GNRO-2015/00046

SUBJECT: Clarification to Fluence Methodology License Amendment Request letter
GNRO-2014/00080 dated November 21, 2014 to include DRAFT marked-up
UFSAR pages and a Regulatory Commitment to revise the GGNS UFSAR
upon NRC approval of the Fluence Methodology LAR
Grand Gulf Nuclear Station, Unit 1
Docket No. 50-416
License No. 29

DRAFT Marked-Up Pages of Affected GGNS UFSAR Chapter 4

FIGURE 4.3-29

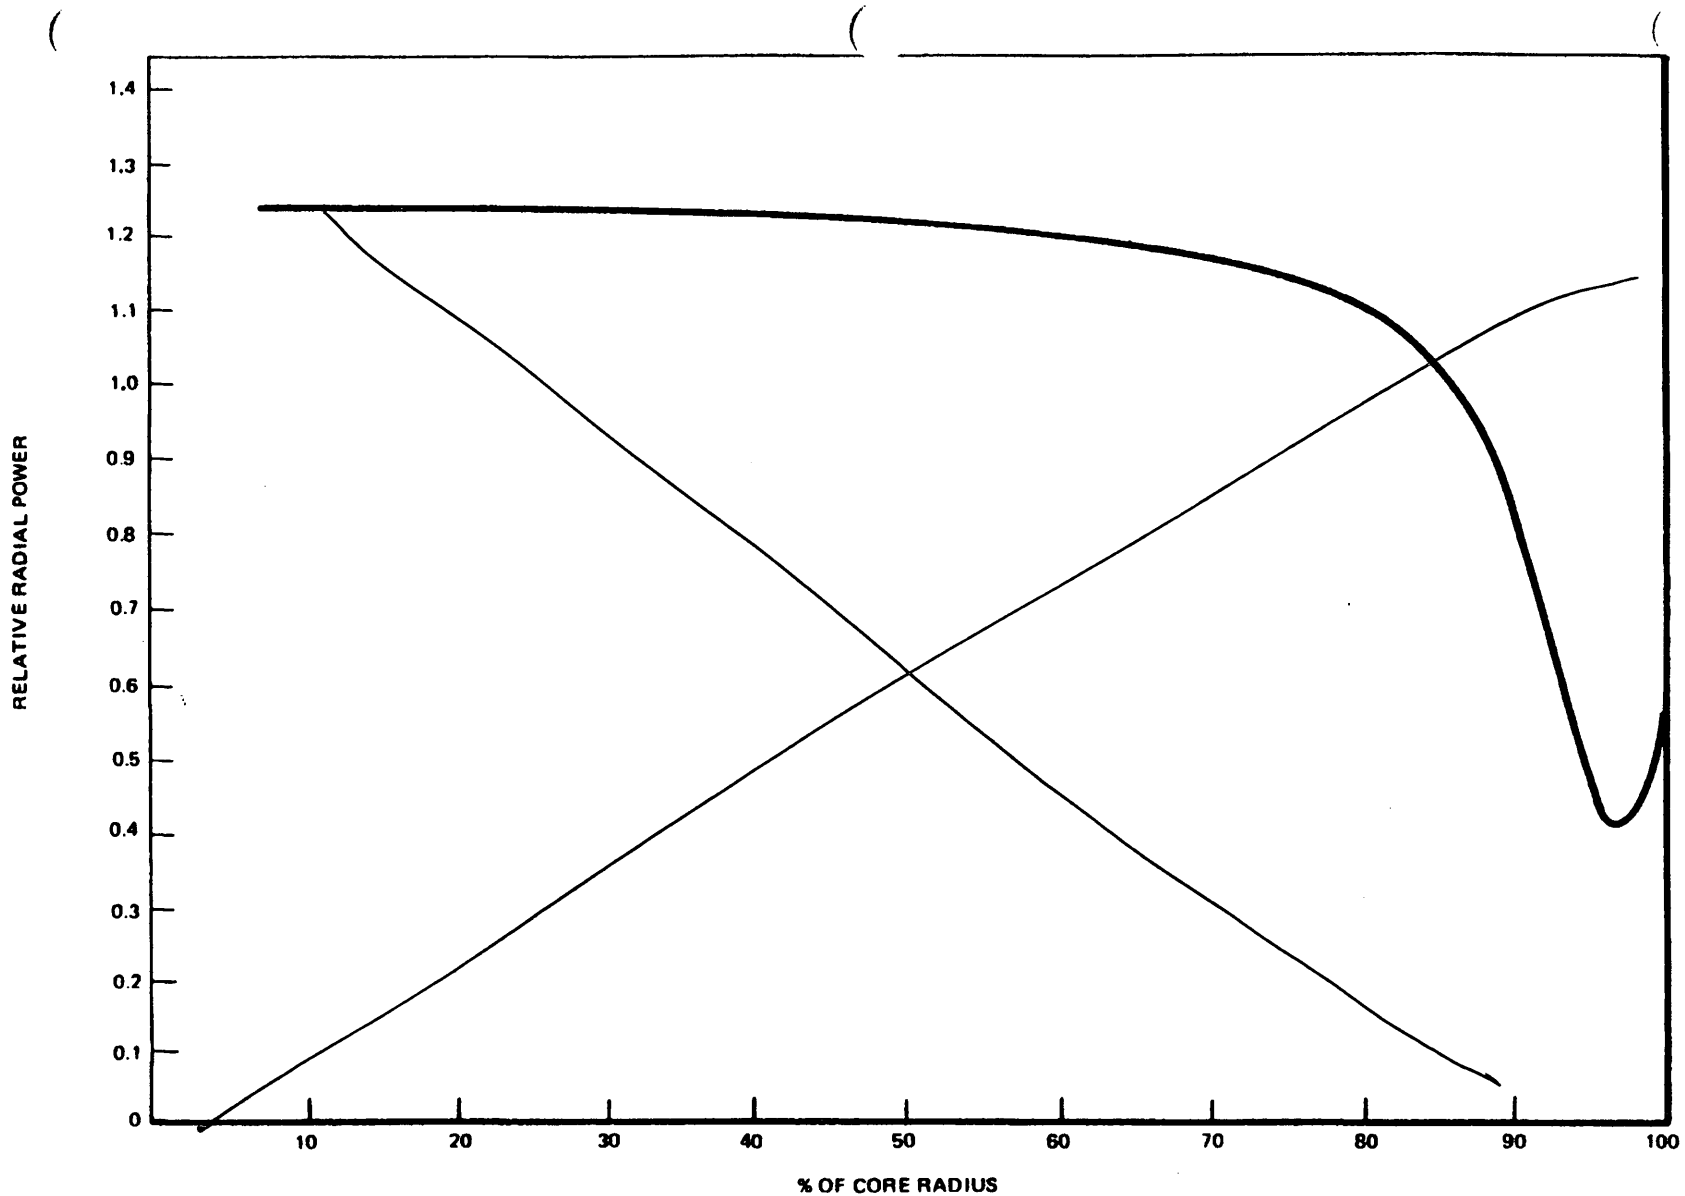
three The neutron fluxes at the vessel have been calculated using the ~~one-dimensional discrete ordinates~~ transport code described in subsection 4.1.4.5. ~~The discrete ordinates code was used in a distributed source mode with cylindrical geometry. The geometry described six regions from the center of the core to a point beyond the vessel. The core region was modeled as a single homogenized cylindrical region. The coolant water region between the fuel channel and the shroud was described containing saturated water at 550°F and 1050 psi. The material compositions for the stainless steel in the shroud and the carbon steel in the vessel contain the mixtures by weight as specified in the ASME material specifications for ASME SA 240, 304L, and ASME SA 533 grade B. In the region between the shroud and the vessel, the presence of the jet pumps was included ignored.~~ A simple diagram showing the regions, dimensions and weight fractions are shown in Figure 4.3-29.

Calculations of the best estimate neutron fluence, and its uncertainty, to the Grand Gulf Nuclear Station (GGNS) reactor pressure vessel (RPV), core shroud and top guide horizontal and vertical welds, as well as to several beltline vessel nozzles have been performed. The fluence calculations were carried out using a three dimensional (3D) neutron transport model for each fuel cycle starting from cycle 1 through cycle 21. The 3D neutron transport calculations were benchmarked on a plant-specific basis by comparing calculated results against previously performed core region 2D synthesis data as well as by calculation of the calculated-to-measured (C/M) ratios for GGNS dosimetry. In addition, a comprehensive benchmarking report, Reference 41, of MPM methods has been submitted.

The neutron transport calculation procedures and dosimetry analysis methods meet standards specified by the NRC and ASTM as appropriate. In particular, the neutron transport analysis meets the requirements of Regulatory Guide 1.190 (RG 1.190). Since RG 1.190 is focused on 2D synthesis methods, it is strictly applicable to analyses in the active fuel region. Nevertheless, the guidance provided in RG 1.190 was followed to the extent practical for modeling work in the regions above and below the active fuel region. The 3D neutron transport calculations were used to determine detailed fluence profiles at the end of cycle 21 (28.088 EFPY), and projected to exposures of 35 EFPY and 54 EFPY, Reference 42.
